Our Ref C5115/25/E/8329  
8<sup>th</sup> September 2025

Ref: Mining Stability – 27 Moor Lane, Gomersal

Further to the additional site investigation works completed by Haigh Huddlestone, we have reviewed the reports and can now recommend appropriate and specific remedial works for the proposed development at Moor Lane, Gomersal. It should be noted that the following recommendations are in line Drawing No.2539-D-20-002 which is appended to this letter.

Client	Binks Executive Homes			
Project	Moor Lane, Gomersal			
Detail	Proposed Borehole Plan			
Scale	Dwn	Chkd	Date	Dwg No.
1:500@A3	MD		Apr'23	E22/7944/03/02A

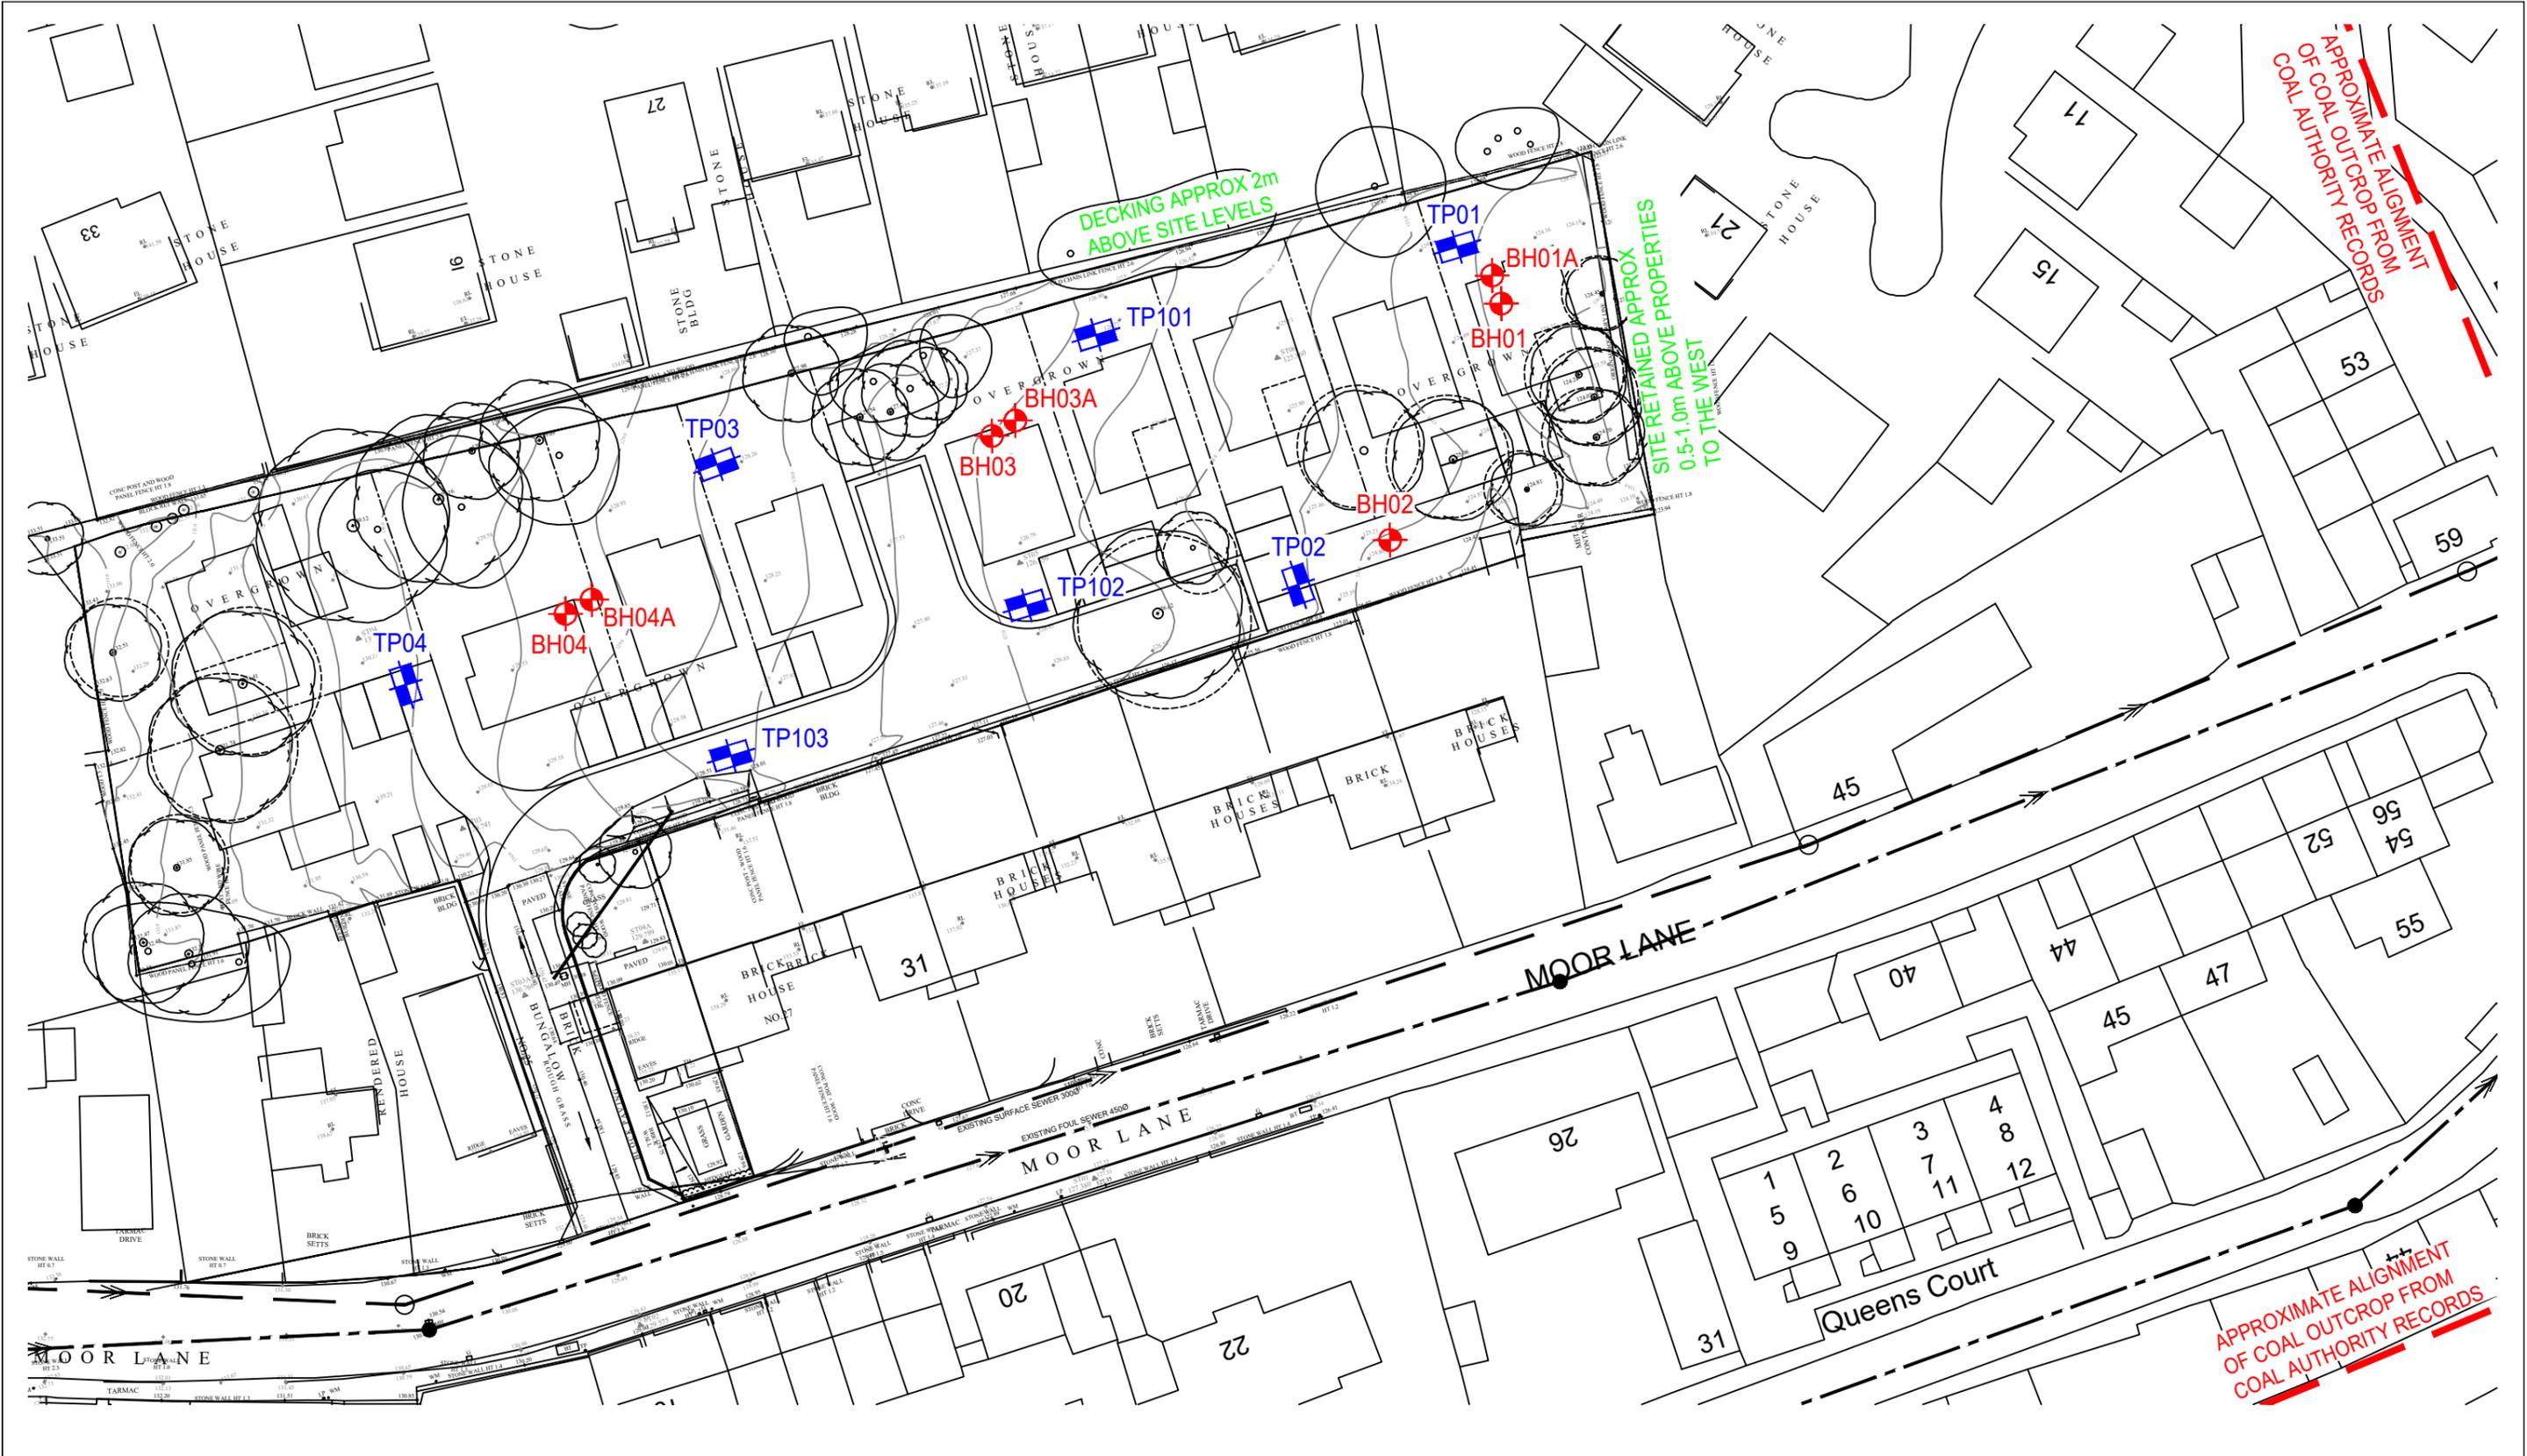
The reports have identified that a thicker intact coal seam (2.0m) thick was recorded in the east of the site at a depth of 21m (BH01/BH01A). The coal seam deepens towards the west. No distinct voiding was recorded, however notable losses of flush and 'broken ground' were recorded at several borehole locations. This would suggest that workings have been prevalent and the above roofs have subsequently collapsed, resulting in 'broken ground'. The broken ground measured in thickness from 2.6m to 3.2m. This would suggest that the collapse of above material has therefore migrated 0.6m to 1.2m above the top of the workings (if assuming a consistent coal seam thickness of 2.0m). The top of the coal seams and 'broken ground' are summarised as follows:

- BH01/BH01A – Coal encountered at 21.0m, 2.0m thickness.
- BHB1 – Broken ground encountered at 25.5m, 3.2m thickness.
- BH02 – Broken ground encountered at 25.8m, 3.1m thickness.
- BHB2 – Broken ground encountered at 26.4m, 2.6m thickness.
- BH03/03A – No coal identified, but only drilled to 10m.
- BHB3 – Broken ground encountered at 26.7m, 3.1m thickness.
- BH04 – No deeper coal identified, borehole drilled to 30m.

It is reasoned that if distinct voids are still prevalent, they would be around 2.0m in thickness; this would correlate with the intact coal seam thickness recorded at BH01/BH01A. In such an instance, around 20m of competent overburden would be required for such voids. As the top of the rockhead is relatively shallow (generally less than 2m), it is reasoned that competent overburden would be in place in most areas as the top of the coal deepens towards the west from a depth of 21m (at BH01/BH01A). Despite the competent overburden, it would be recommended that a raft foundation be installed as a precautionary measure where workings are present at depths of less than 30m; Plots 5 to 10.

Nonetheless, given the quantity and spacing of boreholes drilled, it is reasonable to assume that where workings have been present, the subsequent voids have since collapsed. No distinct voids have been recorded during the investigation; broken ground (collapsed workings) or intact coal (pillars) were identified as opposed to voids. As such, any movement and subsequent surface instability has likely already occurred. To that affect, rafts alone should be a suitable remedial measure.

It should be noted that Haigh Huddleston have recommended in their reports that a grouting programme be undertaken. As broken ground was detected, low pressure grouting techniques would not be recommended. A high-pressure grouting technique (with grout pressures as high as 6 bar) should be adopted to ensure that ground improvement of the collapsed ground is undertaken. The advice of specialist contractors should be sought in order to establish the most appropriate method of grouting for the site, and in order to formulate a detailed and satisfactory remedial proposal. However, for budgetary purposes and as per the Haigh Huddleston report (July 2025), it is recommended that this be limited to Plots 9 and 10 where the workings were shallowest and sufficient competent overburden would not be present i.e. 10 times the working thickness. Rafts are also required for these two plots. Moreover, given the working thicknesses, it is considered that rafts will be required for Plots 5 to 8 to cover any latent risk, albeit grouting is not considered necessary in these locations.
